GOVERNMENT OF THE DISTRICT OF COLUMBIA
DEPARTMENT OF CONSUMER AND REGULATORY AFFAIRS
OFFICE OF THE ZONING ADMINISTRATOR

Re: Zoning PDRM – 919 R Street, NW – Subject Property

Attachment: Plan Set dated 2-29-16

C4 A0002 ZONING BUILDING SECTION
1/8" = 1'-0"

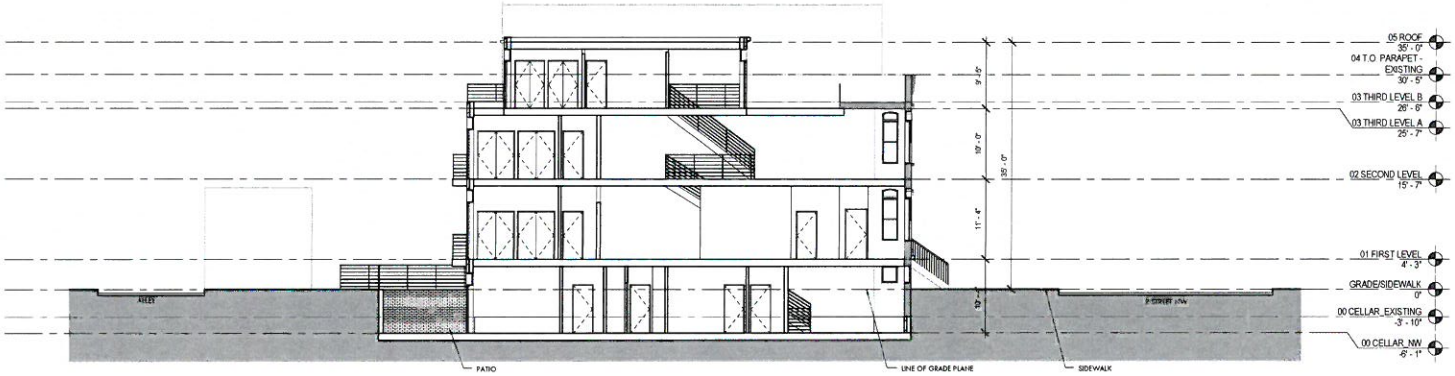
3 – Related to lot occupancy, by adding a third floor, you would be worsening an existing court condition, so you will covering the area adjacent to the third floor addition with a trellis (with framing members spaced 24" [or less] on center – material TBD). However, you will not be covering the portion of the existing court adjacent to the existing building at two stories.

5 – Under the current R-4 regulations, the maximum building height, measured from the middle of the front of the building at grade to the highest point of the roof, exclusive of a parapet, is 35'-0."

7 – We discussed the designation of the lowest level as a cellar in that the ceiling is not more than 4' from adjacent grade at the front and the rear of the existing building. You are providing a sunken patio and an areaway for egress, but since there are no FAR requirements in an R-4 zone, the their potential contribution to FAR is irrelevant. The cellar designation is not counted as a story per zoning definition.

B4 A0002 ZONING SITE PLAN
1/8" = 1'-0"

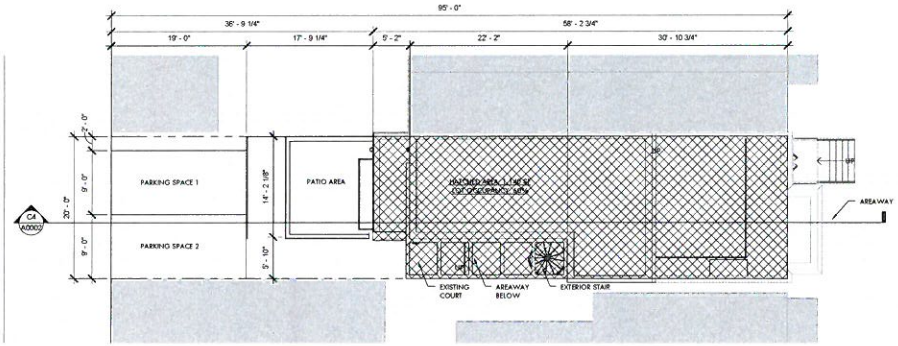
2 – The allowable lot occupancy is 60% and you will be bring it into compliance by demolishing a portion of the rear of the building to bring it into full compliance.

6 – Currently, there are no off-street parking spaces, but you will be providing (2) 9' x 19' parking spaces, even though only one is required per Section 2101.1 of the Zoning regulations.
